Access Compliance Report

Public Rights-of-Way

(Curb Ramps)

Intersection ID: 6370	Main Street: LAKE_RD	Cross Street: MILHAVEN_LN	Location: NW
ADA ID: B77470489B4B	Ramp Type: Para	Initial Pass/Fail: Fail	Overall Compliance: No
		Severity Score: 12.5

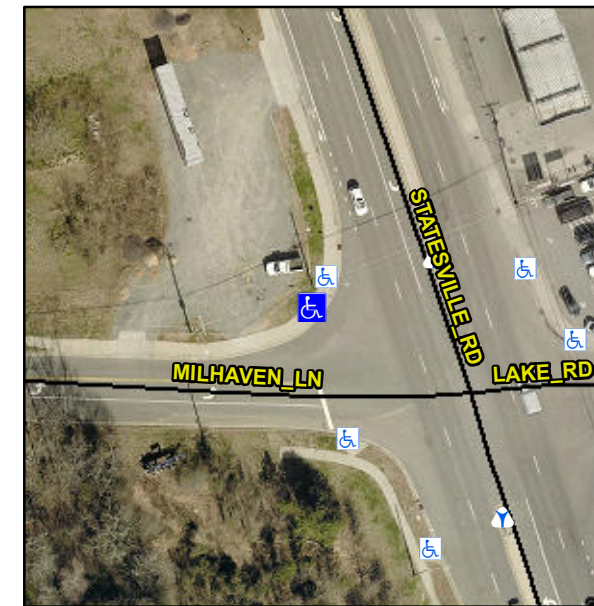
LT RP < 5%

R304.3.2

Remove & Replace Entire Ramp.
